AEMC reference: REL0051

Comments on Reliability Standards and Settings Review Draft Report

AEMO Submission to Draft Report: Reliability Standards and Settings Review 2014

Figure 1 – Example of modelled USE based on monte-carlo based plant outages and using a mix of 10% and 50% probability of exceedance demand forecasts.

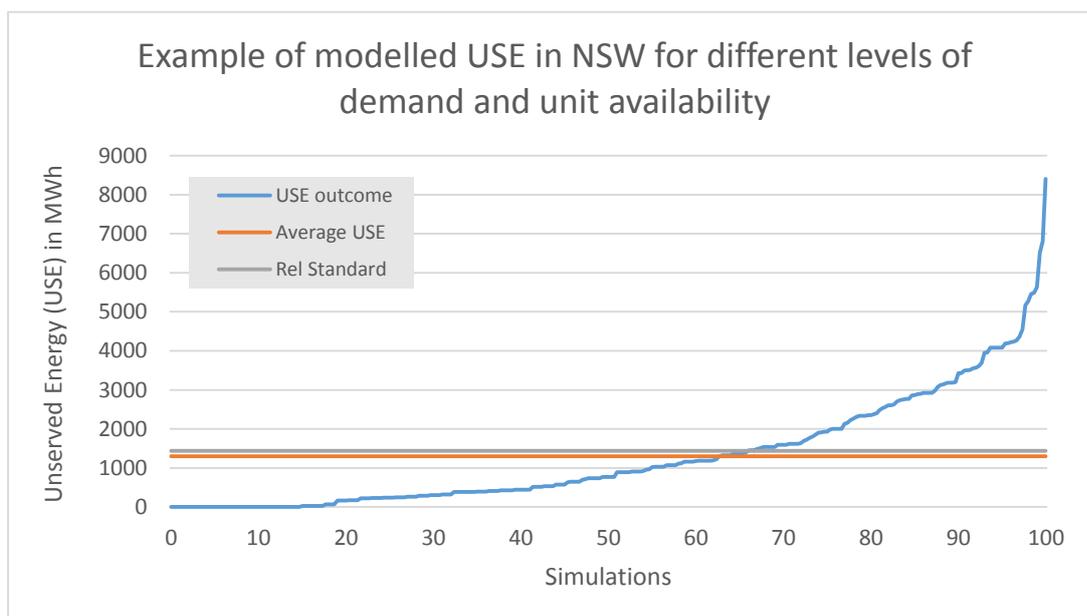
AEMO suggests the Final Report clarify this is a probabilistic standard where year-by-year outcomes can vary significantly, with the majority of years seeing no USE while USE in a few years may exceed the standard. Overall, the standard is still considered met if it is expected to be met on average in the longer term taking into account any trends in demand (such as climate change impacts) and plant performance (changes in plant reliability).

Figure 1 below shows the probabilistic nature of the standard illustrating how a number of different simulations forecast USE outcomes well below the reliability standard, approximately 65% of the time, but at other times the standard may be exceeded substantially. The overall expectation, shown as the orange line, is however just below the reliability standard, which is shown by the grey line.

AEMO propose the discussion of compliance is added to the current description of the standard as per the suggestion in Appendix A when reissued following this review.

Figure 2 – Annualised cost index for OCGT compared with price indices

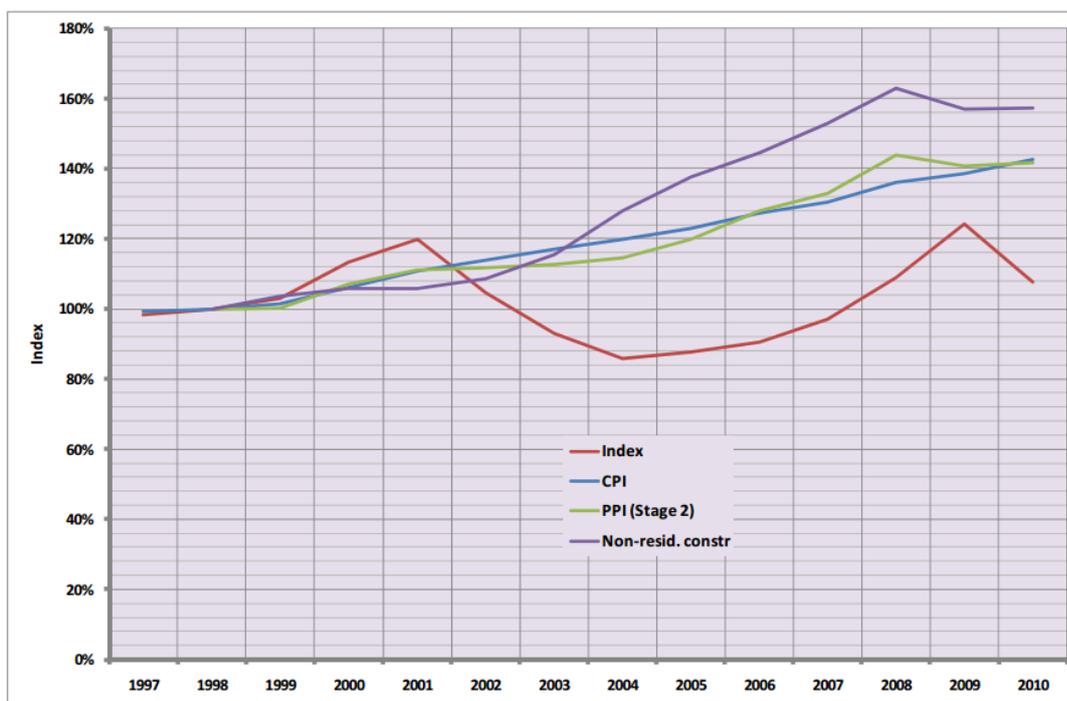
In 2011 SKM studied⁵ OCGT cost trends and tested the nominal cost index of OCGT plants over time (red line in figure reproduced below) against CPI, PPI and the non-residential construction index (1998 = index 100).

SKM concluded that “the PPI (Stage 2) index has a higher correlation coefficient and covariance with the OCGT index than the CPI or non-residential construction indices however this evaluation is based on only 11 data points”. From the figure above, there does not appear to be any substantial difference between using CPI or PPI.

It does show that there are periods where OCGT costs increase above CPI (and PPI) and other periods where the increase is slower; or even declining.

Figure 3 – The nominal cost of an OCGT moves within a band around its mid estimate costs.

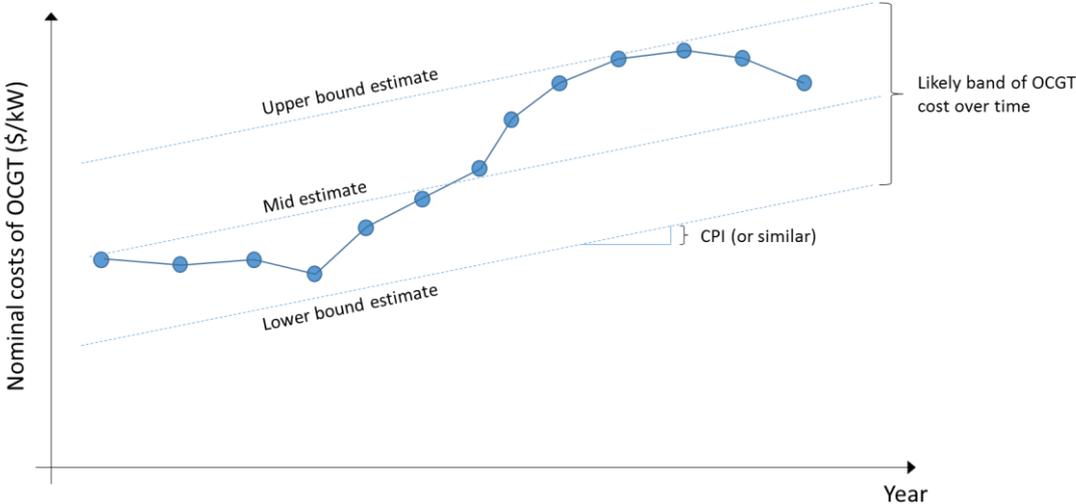
It can be seen to move within a band as illustrated in the conceptual figure below. AEMO suggests it would be appropriate to base the MPC on an OCGT cost equivalent to the upper bound estimate to ensure the system supports investments in new generation also at times with rapid escalation of prices, and bound by the fact that the settings are only reviewed infrequently and should be relatively stable over the longer term.

Selecting a higher MPC than the central estimate gives is similar to basing the MPC on a higher cost OCGT. Future reviews should look further into how wide the band is between the upper and lower bound estimates and what impact this should have on the MPC estimate.
